Project	<b>IEEE 802.16 Broadband Wireless Access Working Group</b> < <a href="http://ieee802.org/16">http://ieee802.org/16</a> >	
Title	<b>PKMv2 Security Framework Corrections</b>	
Date Submitted	<b>2005-01-27</b>	
Source(s)	Yigal Eliaspur, Avishay Shraga, Sanjay Bakshi, David Ayoun Intel Corporation	<a href="mailto:yigal.eliaspur@intel.com">yigal.eliaspur@intel.com</a> Voice +972-54-7884877
	Jeff Mandin Streetwaves Networking	<a href="mailto:sanjay.bakshi@intel.com">sanjay.bakshi@intel.com</a>
	Ren Jing, Li Rui, Tian Feng ZTE Corporation	<a href="mailto:avishay.shraga@intel.com">avishay.shraga@intel.com</a> <a href="mailto:david.ayoun@intel.com">david.ayoun@intel.com</a>
	YongChang	
	Samsung	
	Chulsik Yoon	
	ETRI	
	Shujun Dang, Jianjun Wu	
	Huawei Technologies Co.,Ltd	
Re:	IEEE P802.16e/D5a	
Abstract	There are still areas in the PKMv2 security framework that requires major corrections This contribution proposed a resolution for those major issues.

# PKMv2 Security Framework Corrections

**Figure xx1: AK with RSA only authorization process**

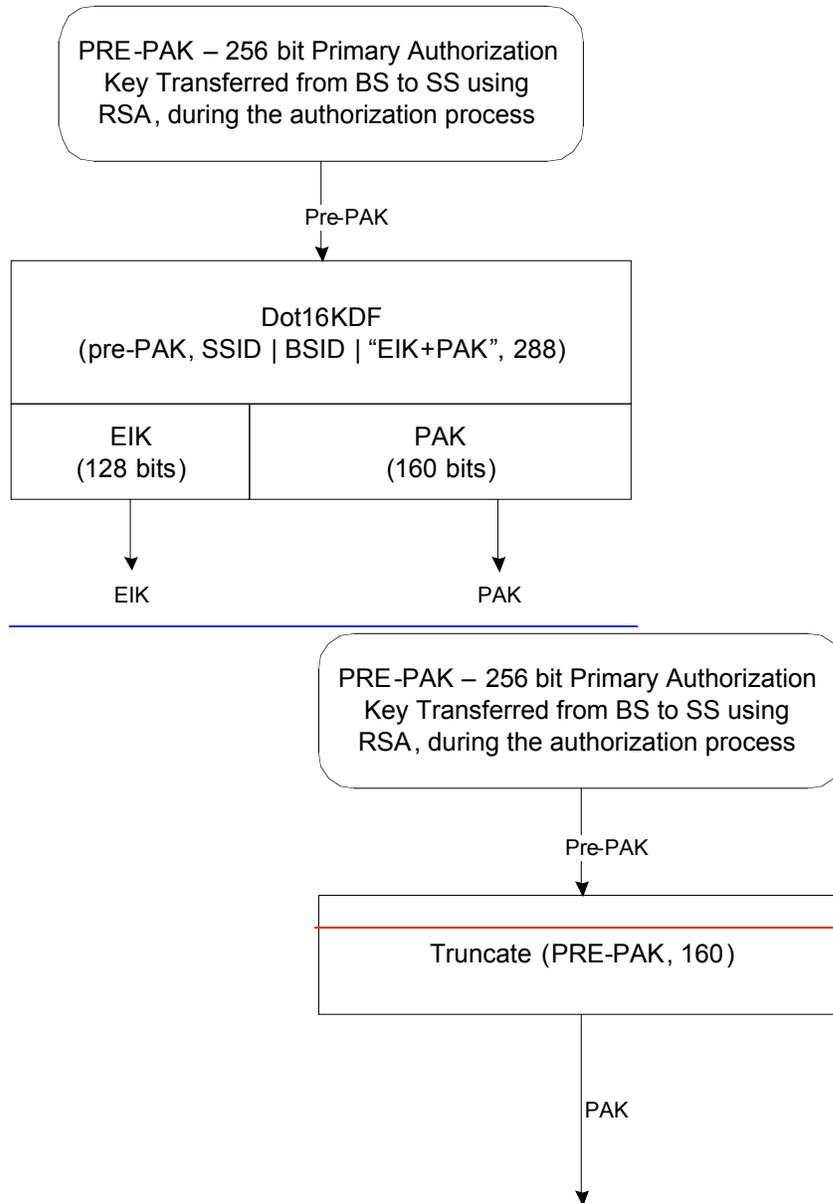
Figure xx1 outlines the process to calculate the AK when the authorization process has taken place, but where the EAP based authentication process hasn't taken place, or the EAP method used has not yielded an AAA-key:

**Figure xx2: AK with RSA+EAP authorization process**

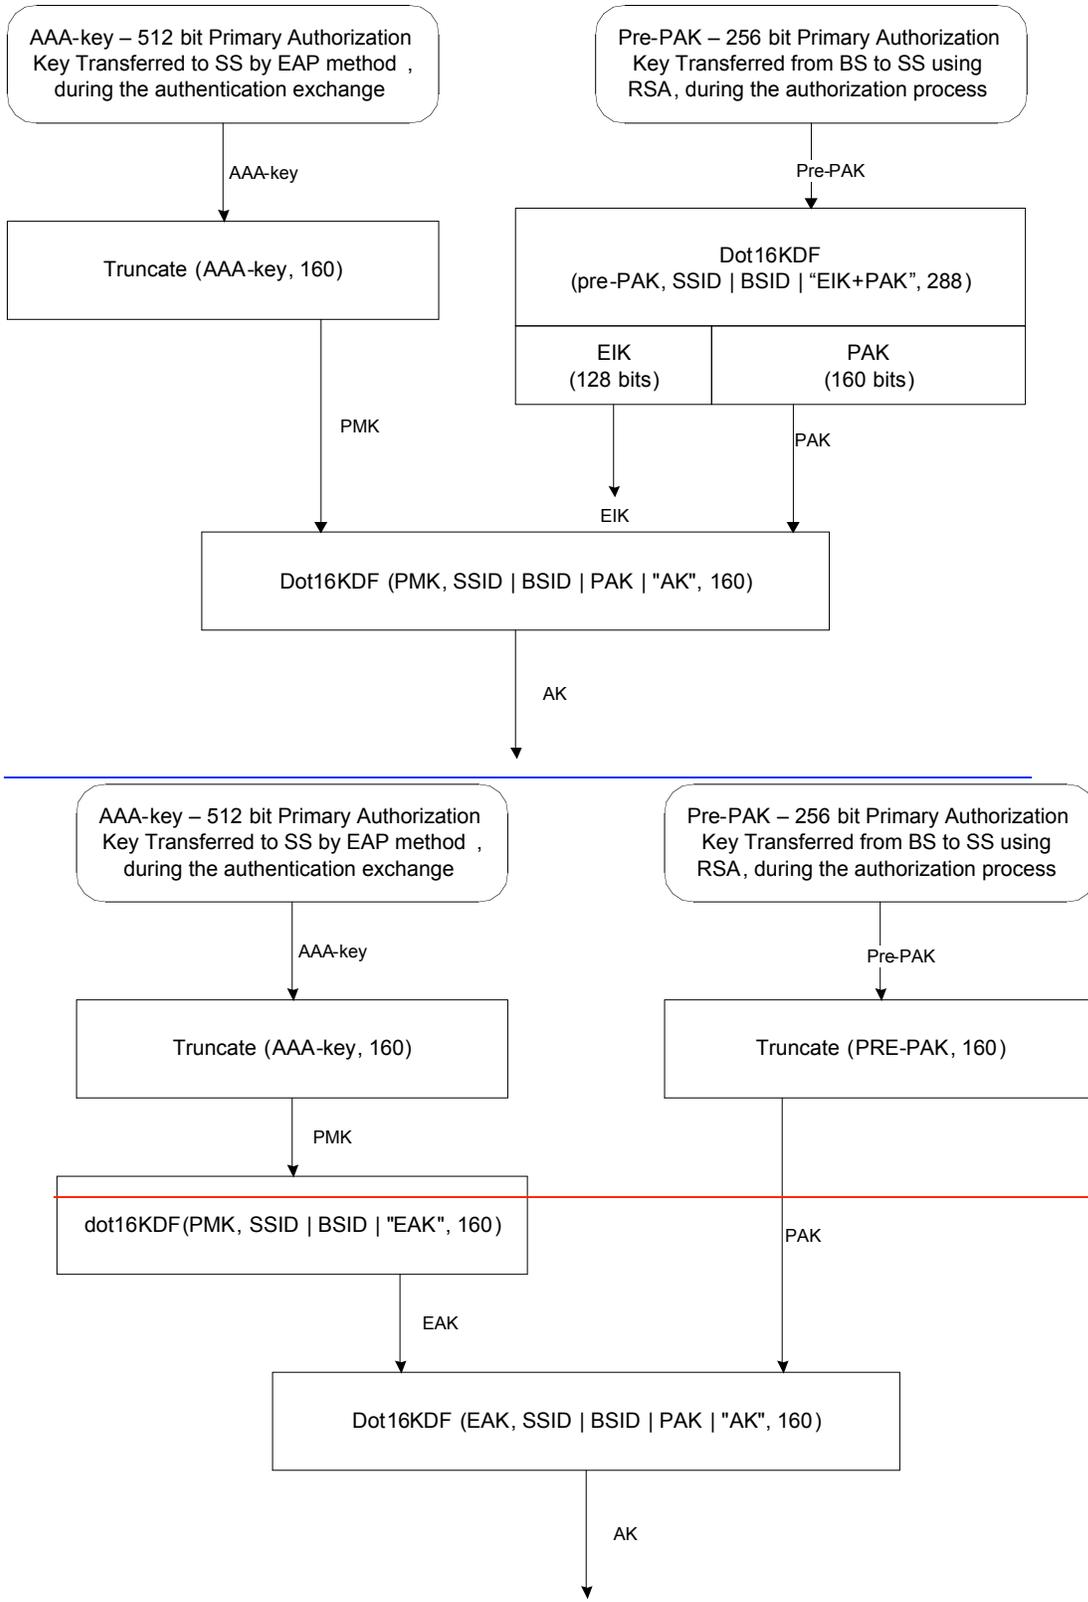
Figure xx2 outlines the process to calculate the AK when both the authorization exchange has taken place, yielding a PAK and the EAP based authentication exchange has taken place, yielding an AAA-key:

**Figure xx3: AK with EAP only authentication**

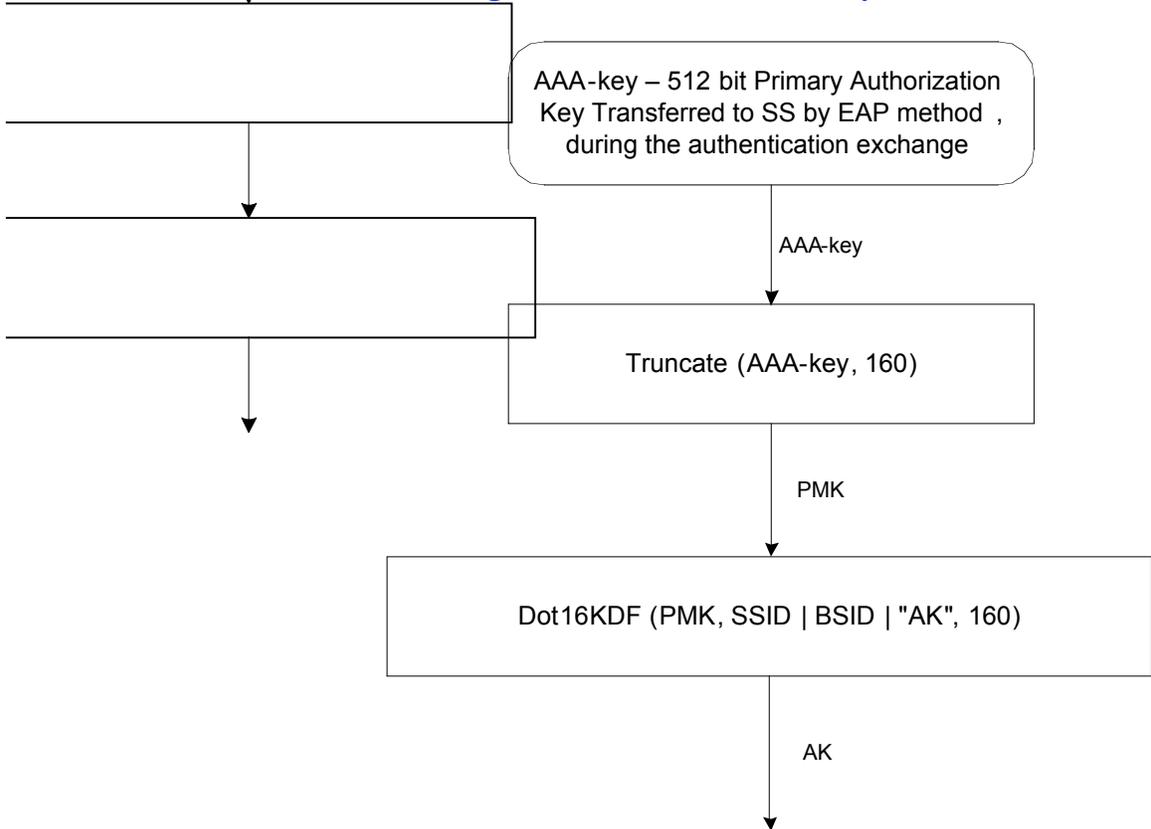
Figure xx3 outlines the process to calculate the AK when only the EAP based authentication exchange has taken place, yielding an AAA-key:

**Figure xx4: ~~AK~~ HMAC/OMAC/KEK ~~key~~ derivation from AK**

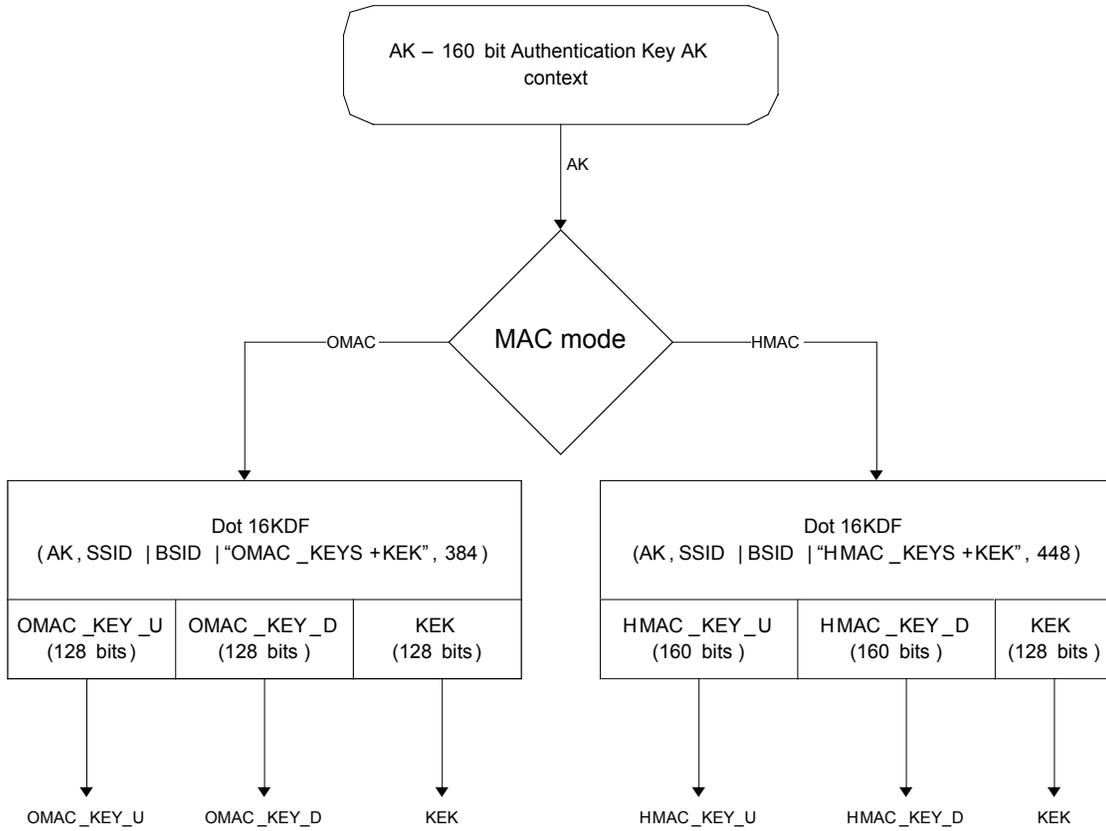
Figure xx4 outlines the unicast key hierarchy starting from the AK:

Figure xx5: ~~AK~~-MTK key derivation from MAK

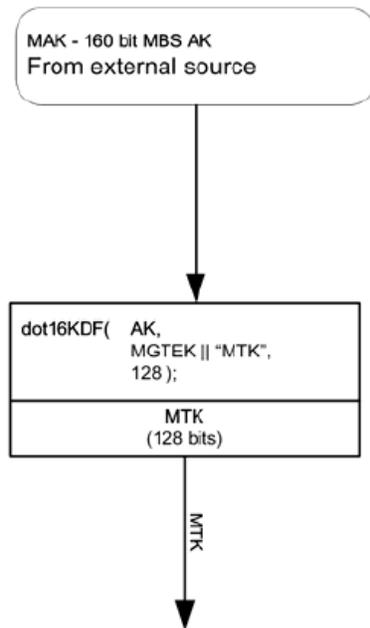
Figure xx5 outlines the MBS key hierarchies starting from the MAK:
